HISTORIC PRESERVATION COMMISSION
Hearing: February 23, 2012, March 8, 2012
& March 22, 2012
Staff Report

CASE NUMBER: HPC12- 65
CITATION ISSUED: No
ADDRESS: 8 W 2ND ST
APPLICANT NAME: Rev. Helen S. Smith
PREPARED BY: Lisa Mroszczyk Murphy
DATE: March 15, 2012

CASE NUMBER: HPC12-100
CITATION ISSUED: No
ADDRESS: 103 W 2ND ST
APPLICANT NAME: Robert Kelley
PREPARED BY: Lisa Mroszczyk Murphy
DATE: March 12, 2012

CASE NUMBER: HPC12-120
CITATION ISSUED: No
ADDRESS: 214-214A East 6th Street
APPLICANT NAME: Lori Duke
PREPARED BY: Christina Martinkosky
DATE: March 14, 2012

PROPOSED GATE FOR ALLEY/WALKWAY BETWEEN
214 & 214A. E. SIXTH ST.

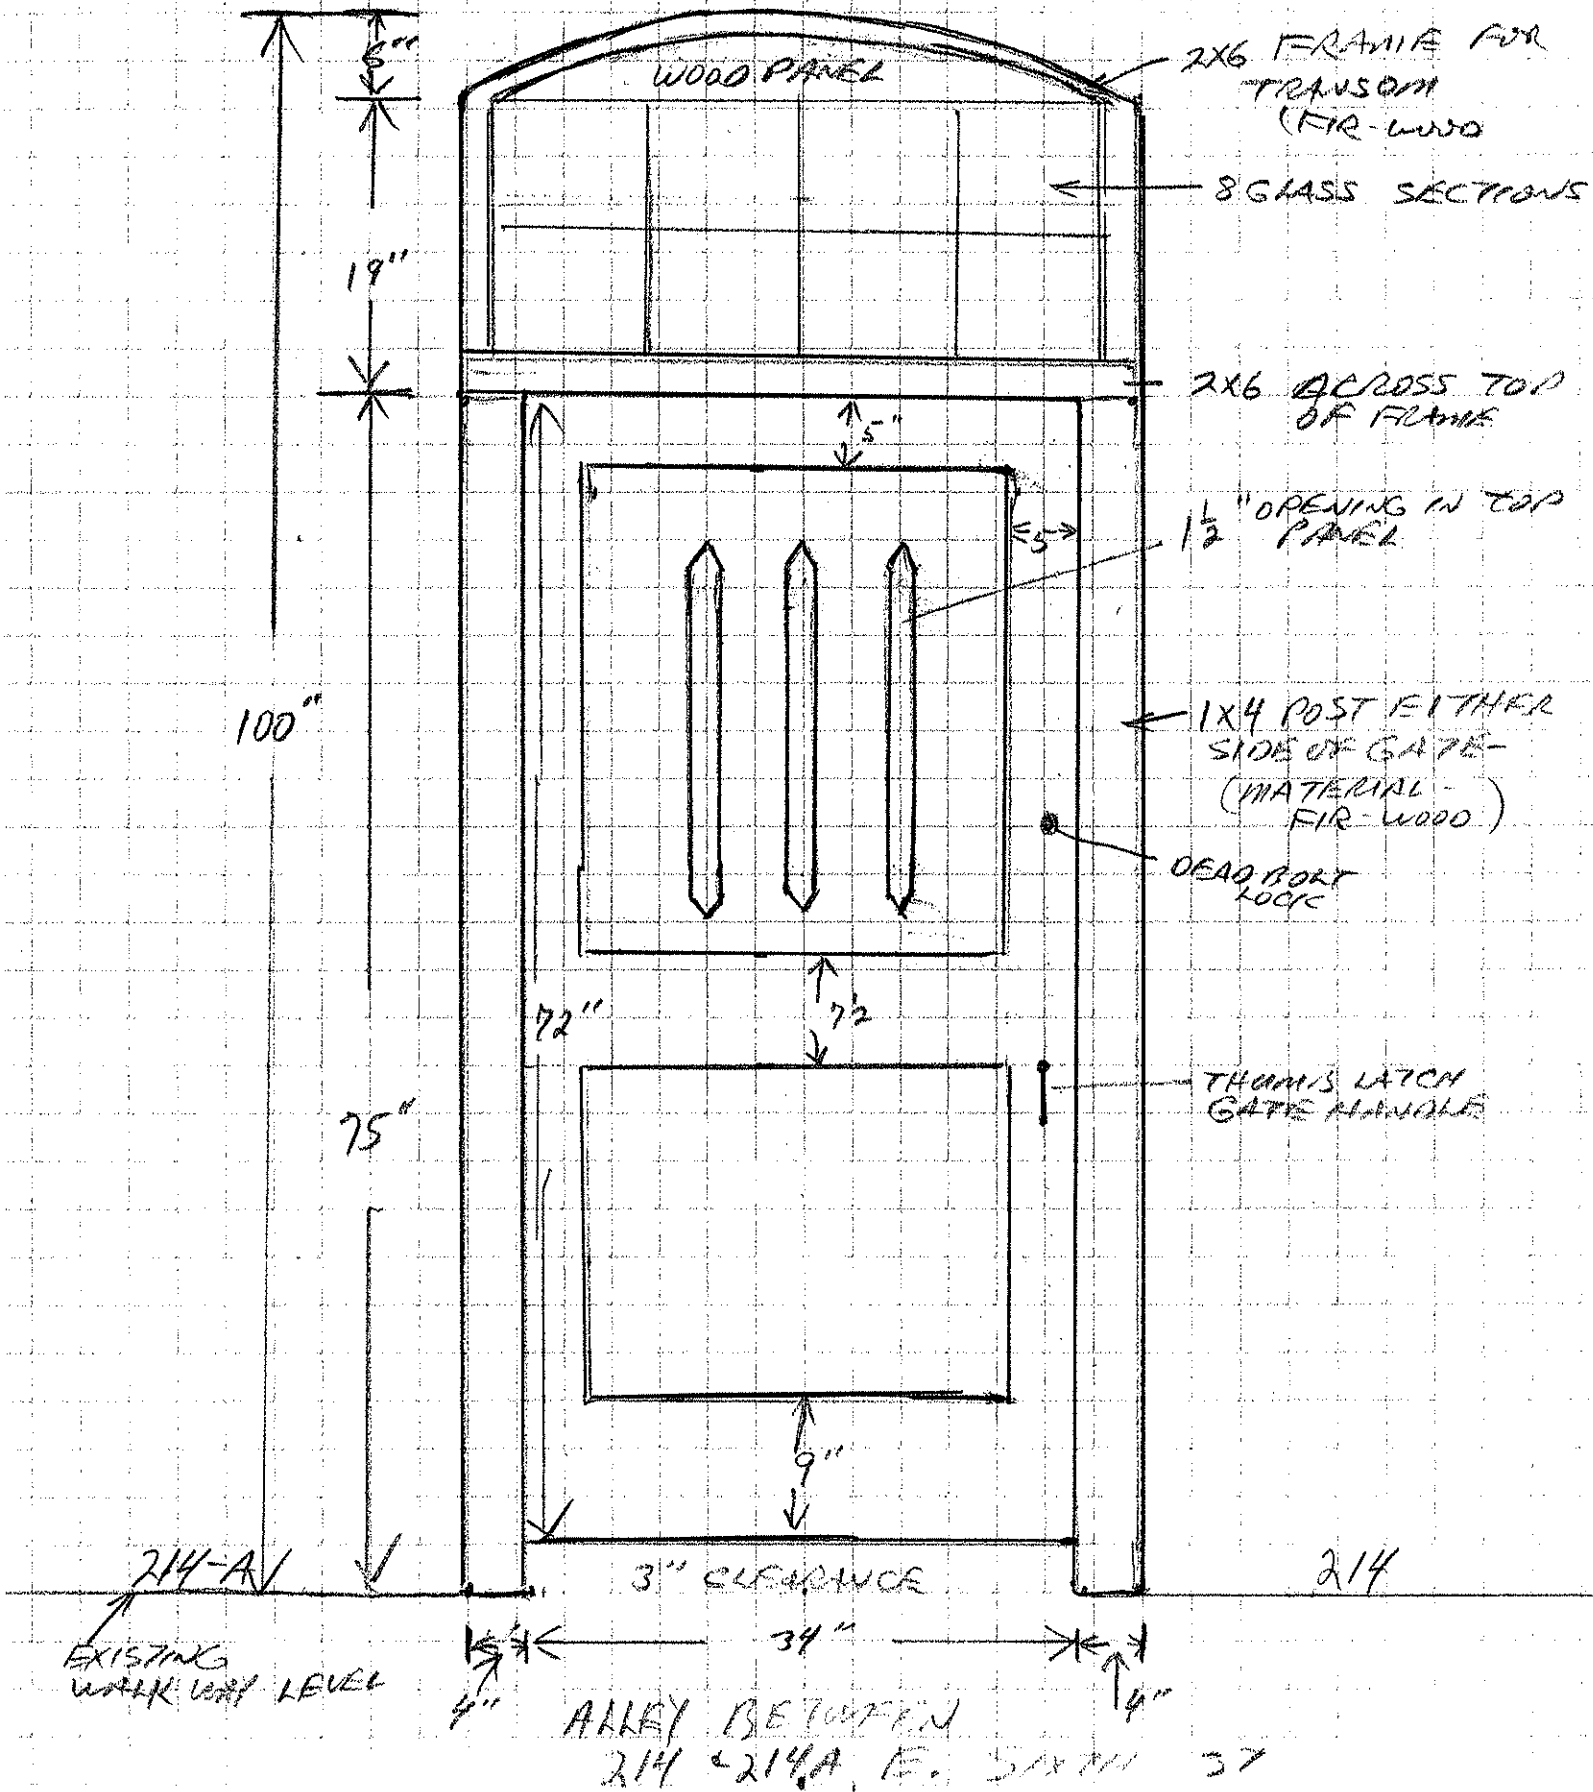
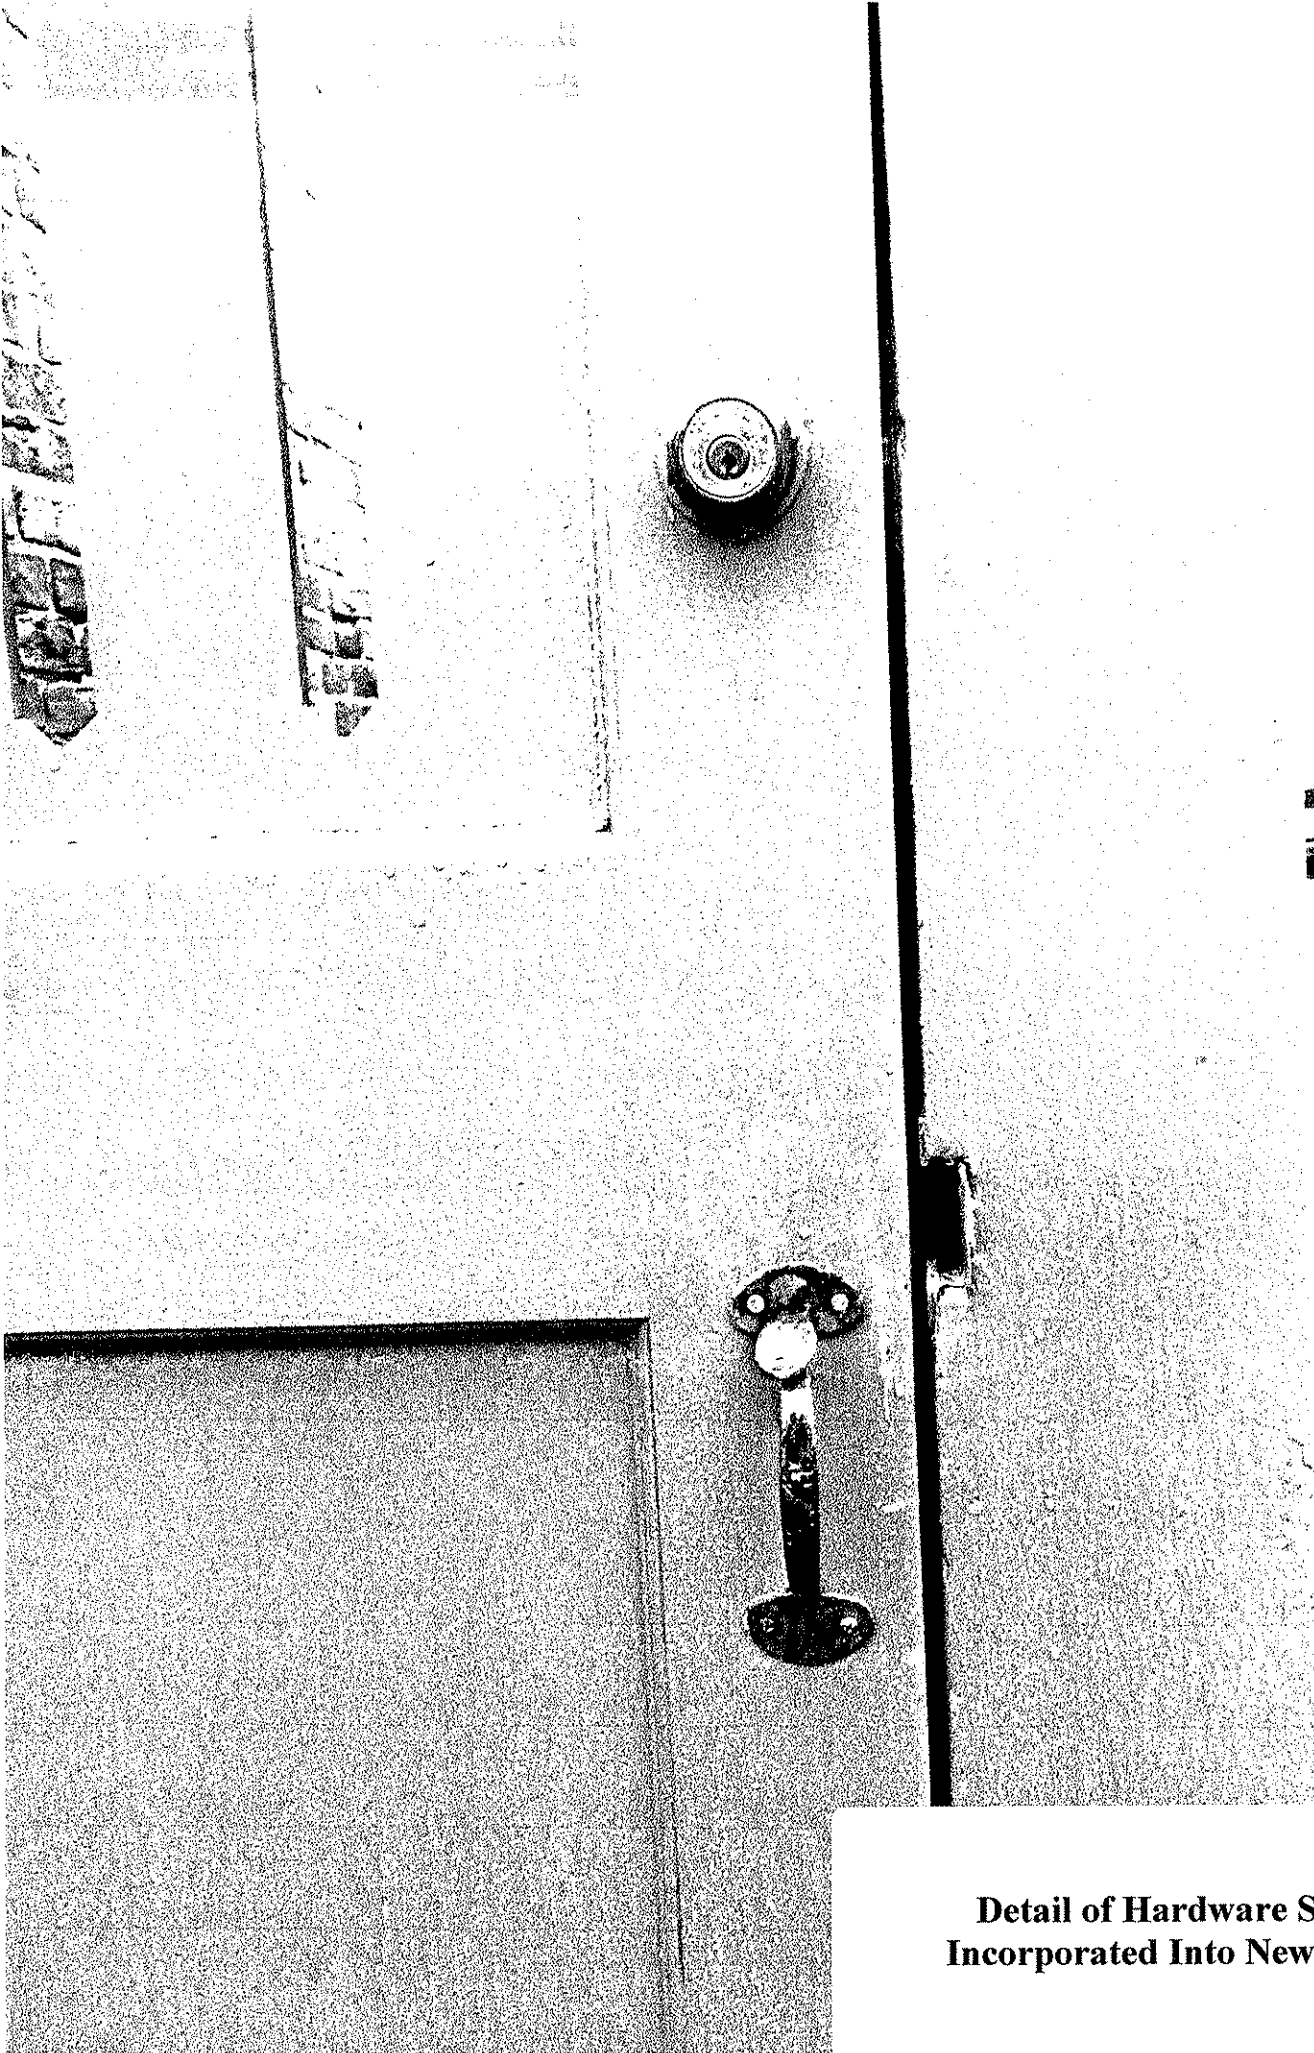
Staff finds that the proposed alley gate and transom does feature an appropriate design. Similar wood gates can be found at 219-221 East 2nd Street and 103 West 2nd Street. Glass transoms above alley gates can also be found within the Historic District. Staff recommends that clear glass be used for the transom.

The height of fences and gates is regulated by City Code. The code allows fences and gates to be six-feet high, including posts, as measured from the final finished grade. The proposed fence is 75" in height; three inches above regulation. Staff recommends that the height of the gate is reduced to 72", and the height of the transom area increased from 19" to 22".

The construction of the gate should be done in a way that minimizes damage to the historic masonry walls and brick walkway. Staff recommends that any required fastening of the gate posts to the building must be made through the mortar joints rather than the historic masonry; and that a section of the brick walkway be temporarily removed during construction and replaced in the original running bond pattern.

- Only clear glass is to be set into the transom area;
- The height of the gate is reduced from 75" to 72" and the height of the transom area increased from 19" to 22";
- Any required fastening of the gate posts to the building must be made through mortar joints rather than the historic masonry; and
- A section of the brick walkway must be temporarily removed during construction and replaced in the original running bond pattern. Any footers required for the gate must allow for the bricks to be replaced.
